TITLE OF JOB
 B-5
 BRACKNELL GDNS
 LONDON N.W.3

TITLE OF SHEET
 GROUND & FIRST
 FLOOR PLAN

DRAWING NUMBER
 980 / 150 (R)

TITLE OF SHEET
 ROOF PLAN &
 SECTION A-A & B-B

SECTION B-B

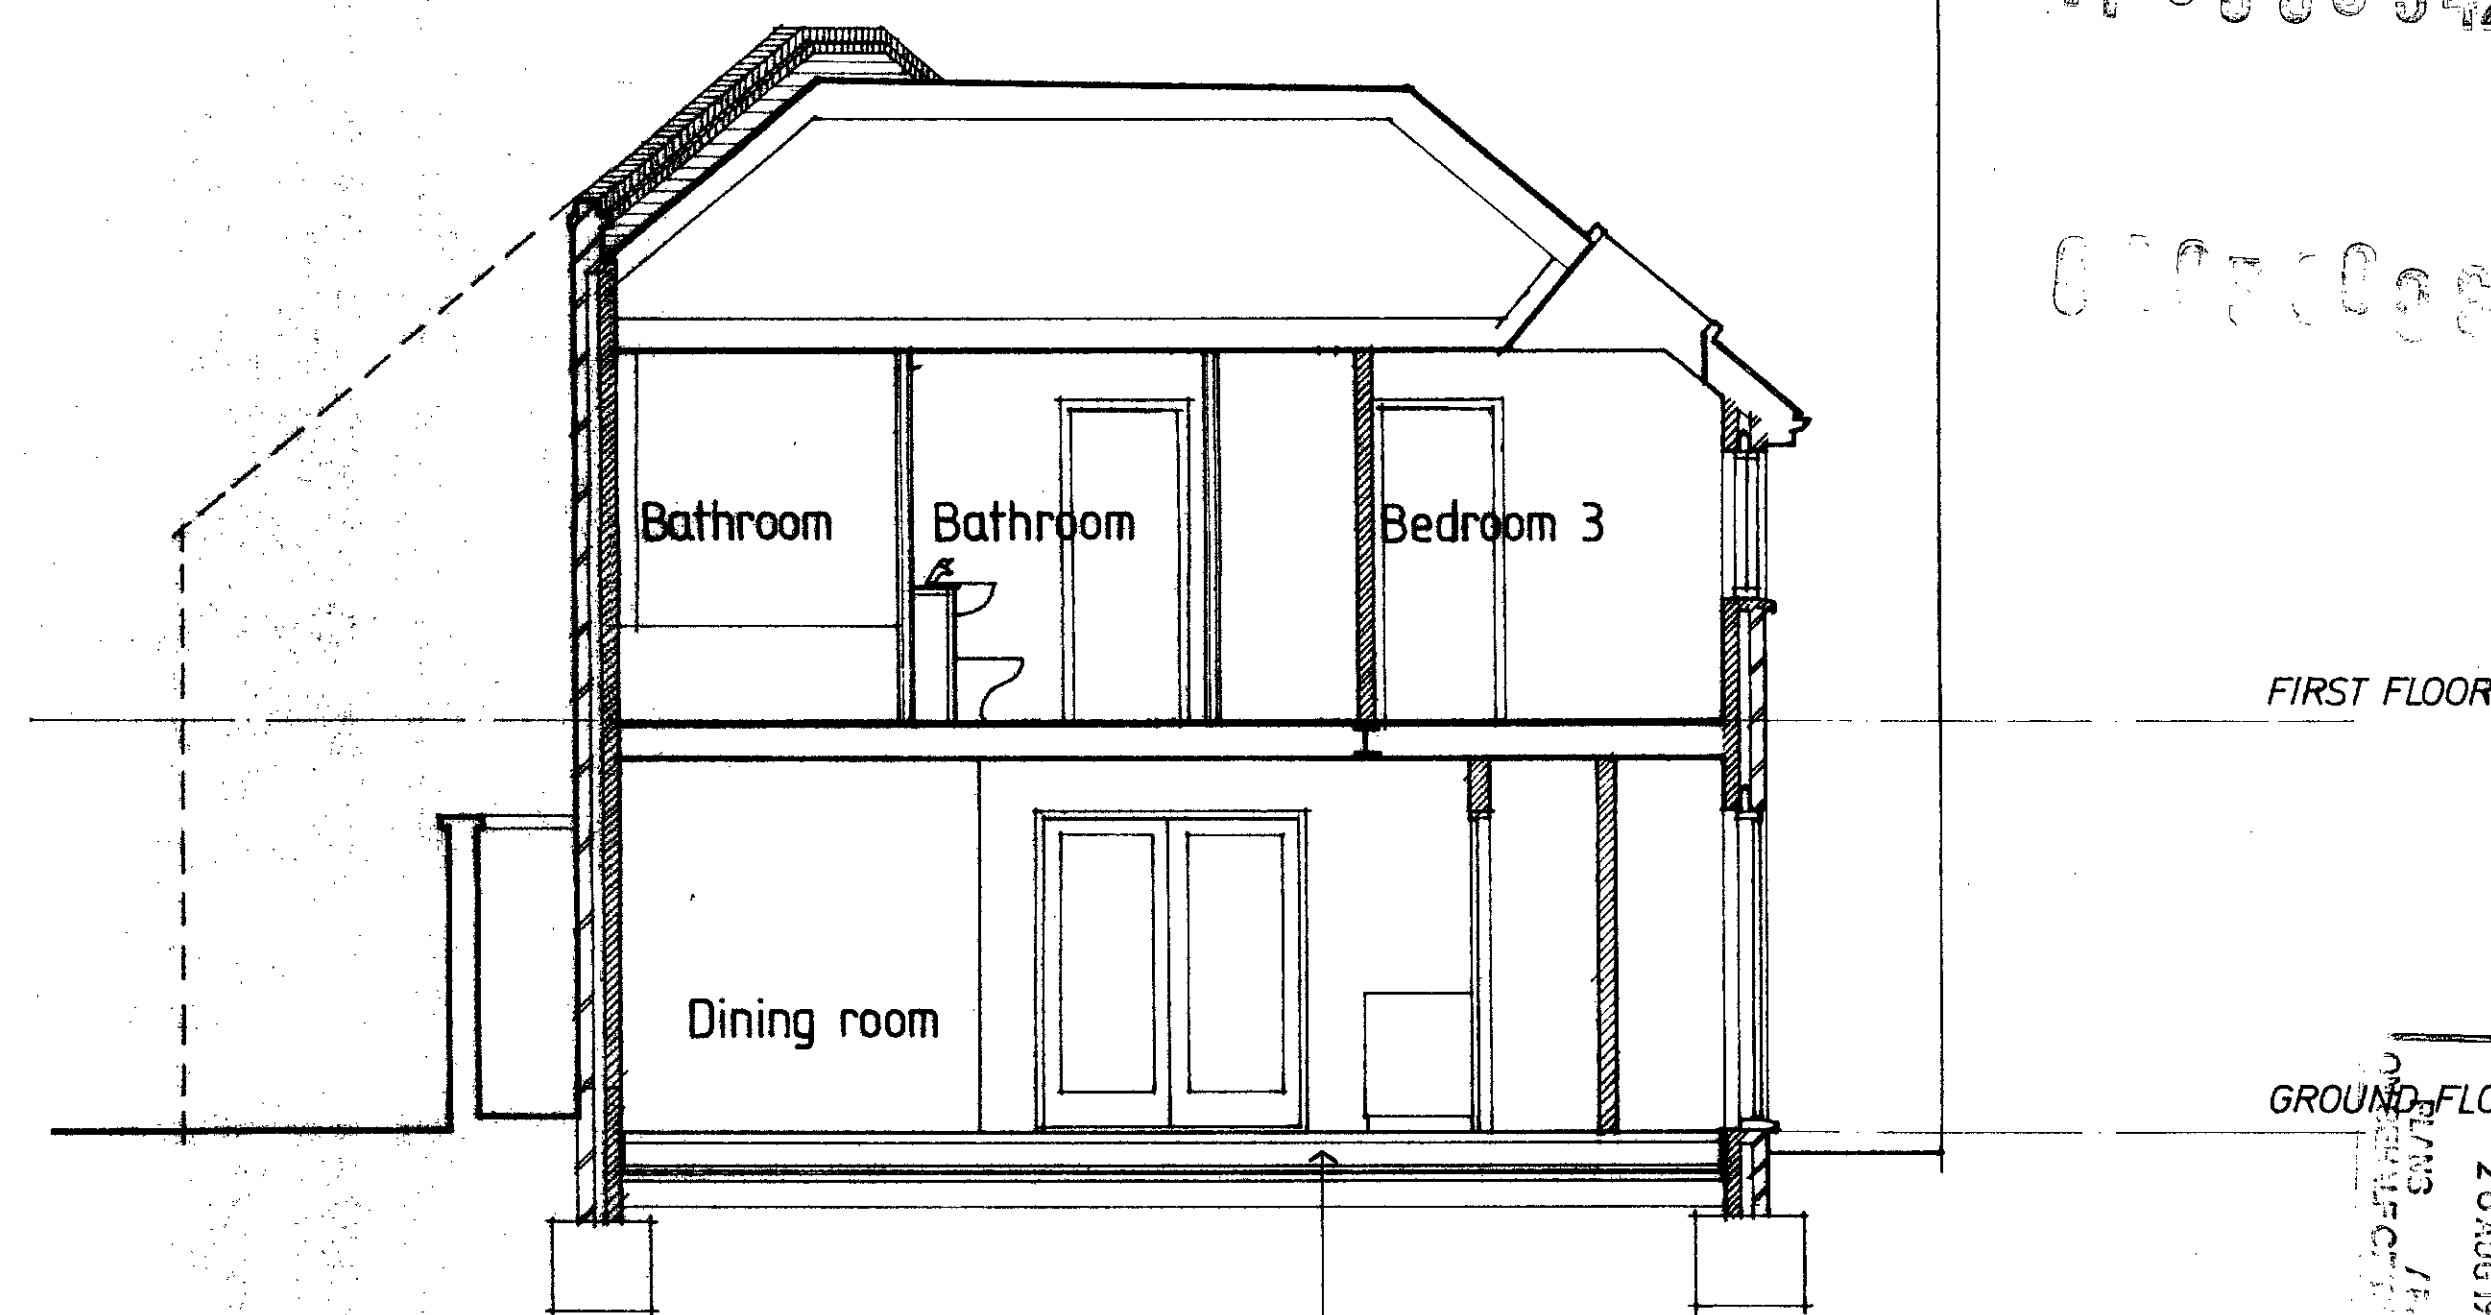
REVISIONS	DATE
(R) EXTENT OF NEW CONSTRUCTION REVISED TO REFLECT ADDITIONAL TAKING DOWN ALREADY COMPLETED TO SAFE GUARD STRUCTURAL STABILITY.	4.93
